Lead Local Flood Authority

Date 18th September 2025

RE: DM/25/1434 – Land Rear Of Chesapeake, Reeds Lane, Sayers Common, Hassocks, West Sussex BN6 9JG

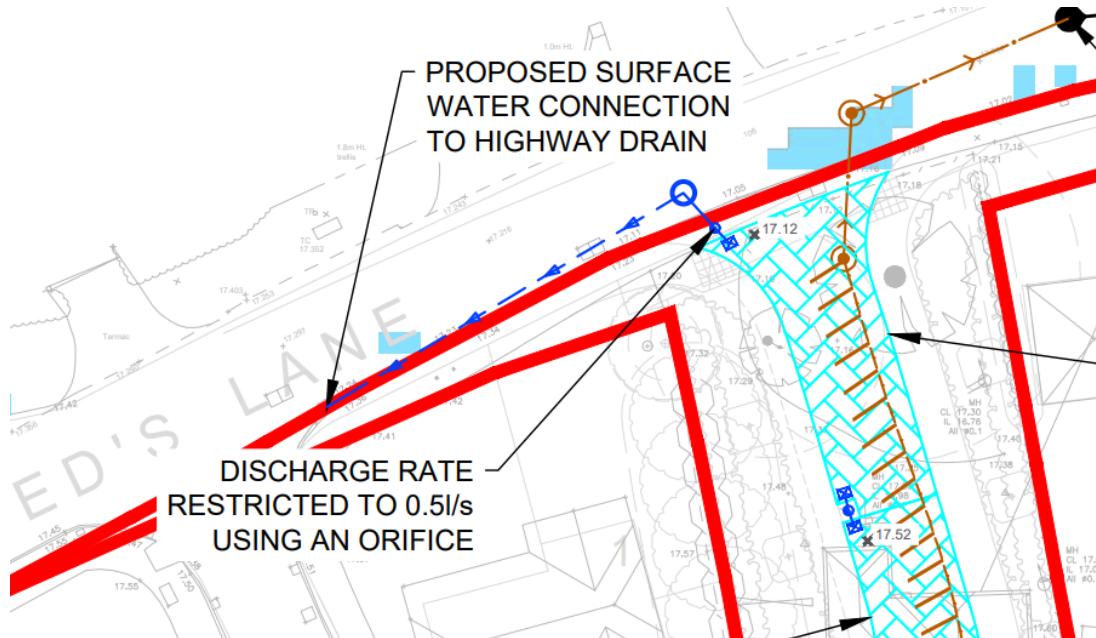
1. Flood storage for the ordinary watercourse in the south of the site will be lost as a result of the ground raising towards the west of the site. As stated in PPG Flood risk and coastal change, on-site level for level compensatory storage accounting for climate change for the lifetime of the development should be provided. This is to ensure surface water which naturally collects in the lower areas of the site currently (in the watercourse floodplain) is not displaced, as this would increase flood risk within the site or elsewhere.
2. The northern catchment, as defined by the applicant, is proposed to discharge at a restricted rate to a highway drain. We require evidence that the owner of the

system accepts in principle connection to their system, and that the receiving system has capacity for additional flows. The applicant is reminded that WSCC highways are unlikely to accept private surface water (from residential areas) into the highway drainage system.

Also in the northern outfall location, it is unclear what direction the existing system flows. We believe the system it is proposed to discharge into falls from west to east, rather than east to west as suggested in the drainage strategy. If there are proposals to contract additional surface water sewers outside the red line boundary, this will also require third party agreements.

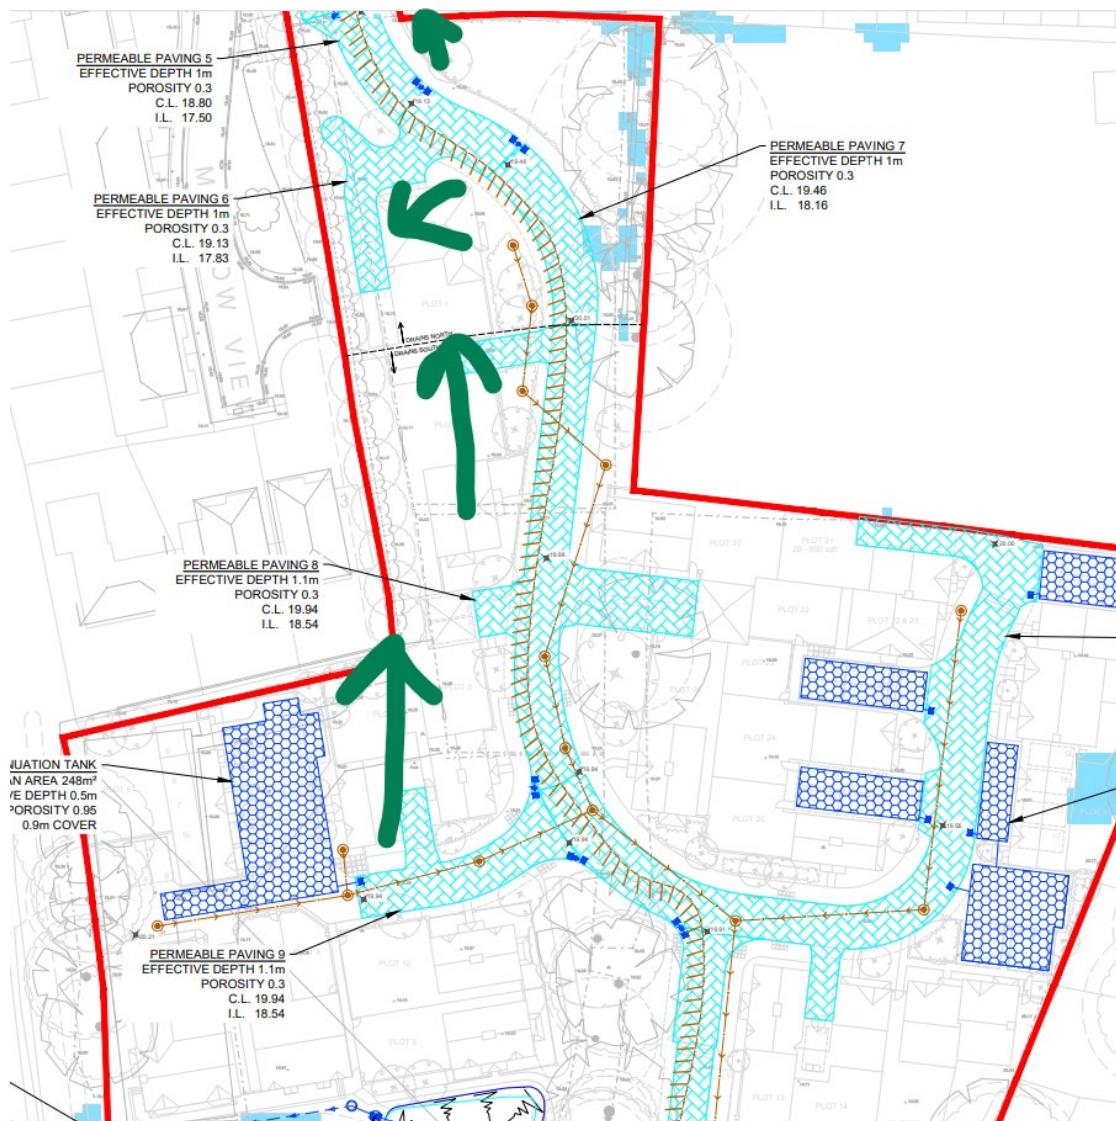
3. The surface water drainage system should mimic natural drainage systems. The topographical survey suggests more of the site drains north than where it is proposed that the new surface water drainage system north catchment begins, as seen below.

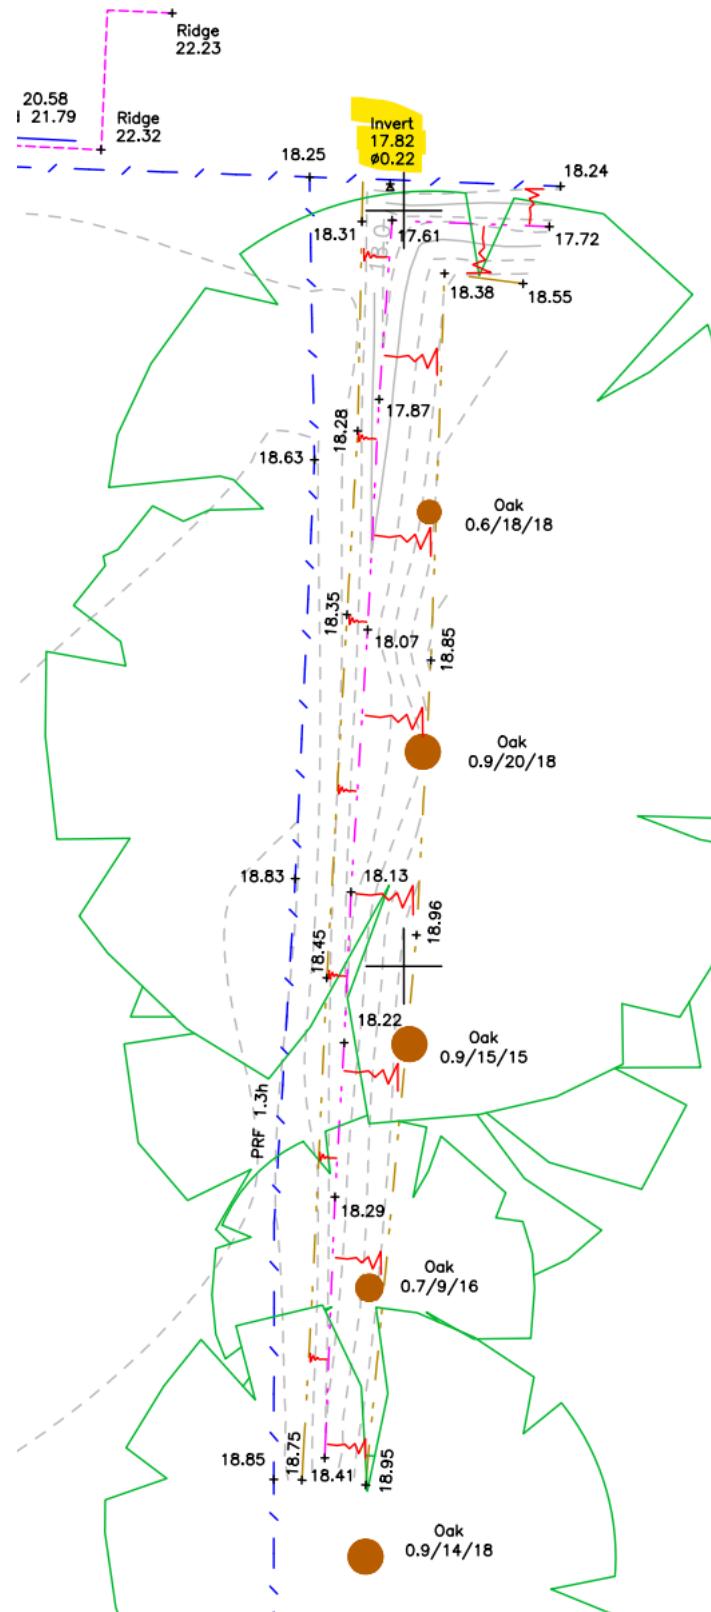
4. It also appears that there might be a shallow ditch on the right-hand side of the site, where the existing line of trees are roughly south of Buff Cottage. There is also an Invert level for what is assumed to be a pipe on the topographical survey, although it is unclear what this relates to.

If it is a watercourse that is connected to the wider network, this should be used for the northern part of the site instead of the highway drainage system. This is because discharge to an above ground surface water body is above discharge to a piped surface water system in the discharge hierarchy.
